Agenda Item # 6

SUB-003675-2026

Resubdivision of the Resubdivision of Revised Bucci Subdivision

- Subdivision approval to relocate the interior lot line between two (2) legal lots of record.

DETAIL SITE PLAN

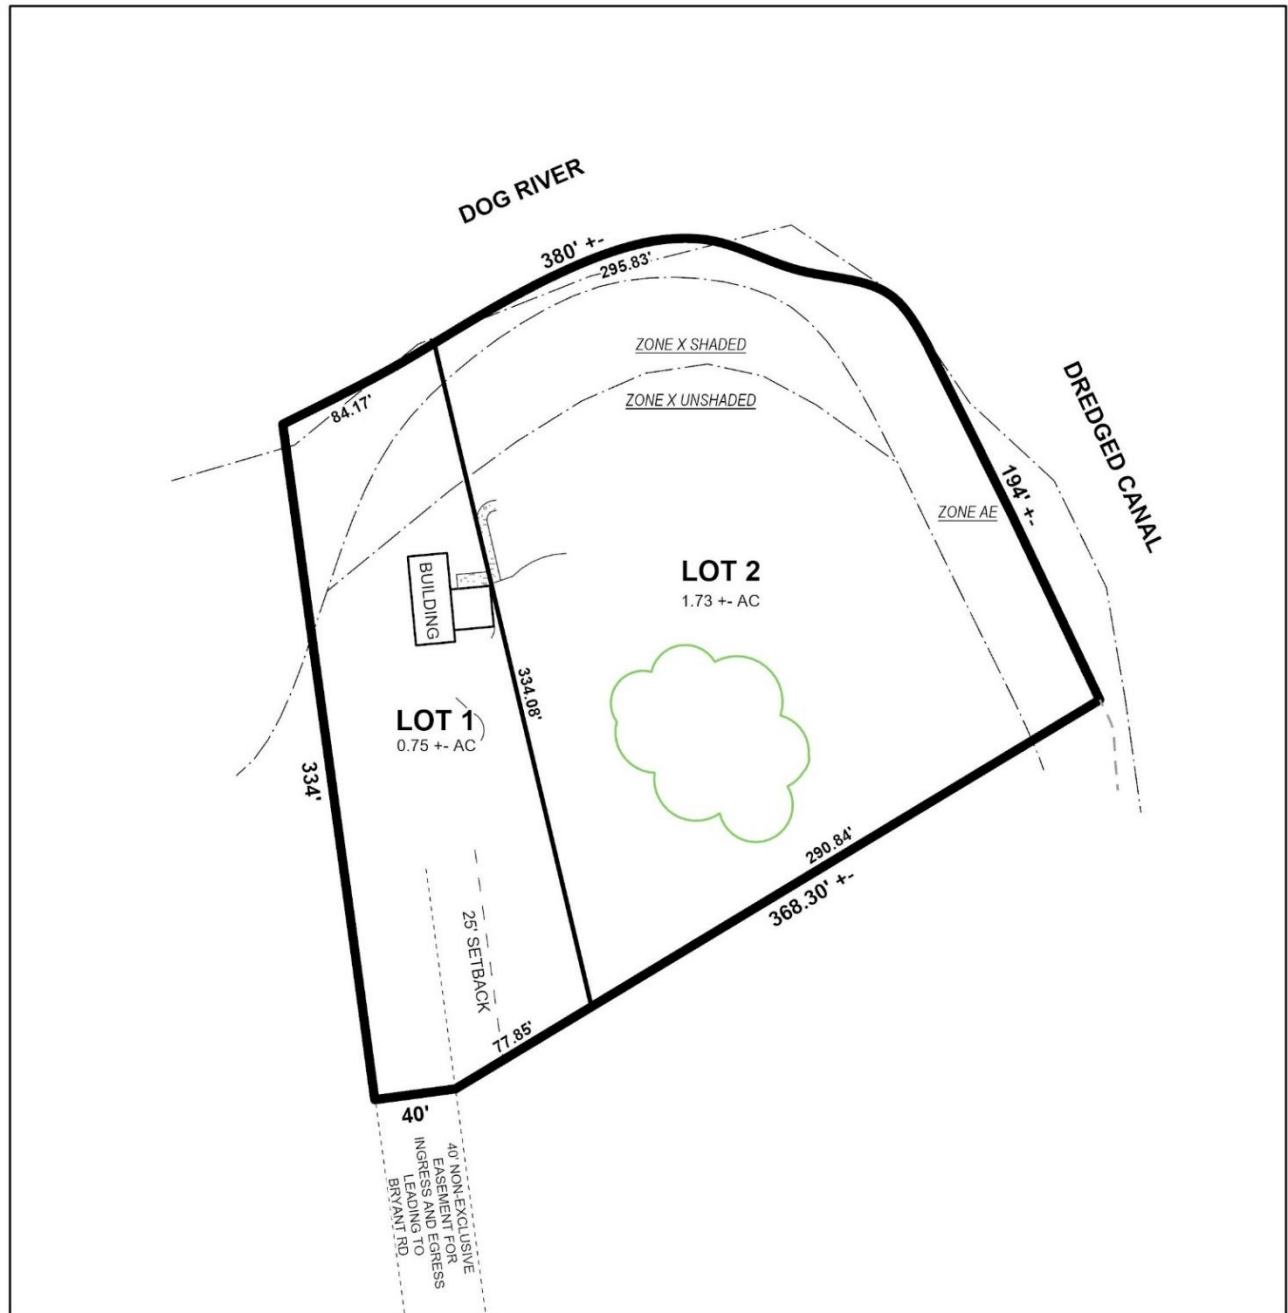
- B. Check the Subdivision Name for duplication of "RESUBDIVISION OF". The legal description indicates that the new subdivision is based on the "Revised Bucci Subdivision".

- C. National Wetlands Inventory (NWI) mapping, as shown on City of Mobile GIS information, indicates that there is potential for wetlands within the property or properties shown on this plat. Show and label the delineated wetlands or provide a note stating that the wetlands shown on this plat are scaled from the NWI data and have not been delineated.

- D. Provide a note that a 25' riparian buffer may be required, during development, along the edge of anything considered by ADEM to be a water of the state.

- E. Retain NOTES 7 - 9.
- F. Delete NOTES #14 and #15.
- G. Add a note - sidewalk is required to be constructed, and/or repaired, along the frontage of each lot, or parcel, at time of new development or construction, unless a sidewalk waiver is approved.

The current subdivision application does not create an additional lot and is therefore consistent with this note. However, the proposed lot configuration would result in two (2) single-family dwellings being located on proposed Lot 2. Because the property is zoned R-1, Single-Family Residential Suburban District, only one (1) dwelling unit is permitted per lot. As such, the applicant must either obtain a Use Variance to allow two (2) dwellings on a single lot or secure demolition permits and remove one (1) of the existing dwellings prior to Final Plat approval, if approved.

It should be noted that the subject site does not have frontage on a public right-of-way, but instead fronts an existing 40-foot easement for ingress, egress, and utilities. As proposed, Lot 2 does not have direct access to this easement. Therefore, if approved, the Final Plat should be revised to extend the western property line of Lot 2 to provide frontage on the existing easement. Additionally, a note should be included on the Final Plat stating that no structures may be constructed within any easement without permission from the easement holder.

The preliminary plat depicts the existing 25-foot minimum building setback line for Lot B of the *Resubdivision of Revised Bucci Subdivision* but does not show setback lines for the proposed lot configuration. If approved, the Final Plat should illustrate the required 25-foot minimum building setback line for both proposed lots, measured from the easement frontage, in accordance with Article 2, Section 64-2-5.E. of the UDC and Section 6.C.8. of the Subdivision Regulations.

The application should be heldover until the June 18, 2026, meeting to allow the applicant time to make one of the following revisions:

1. Either revise the plat to depict three (3) lots;
2. Submit a Use Variance application to allow multiple dwellings on a single building lot; or
3. Obtain a Demolition Permit for one of the dwellings on the proposed Lot 2.
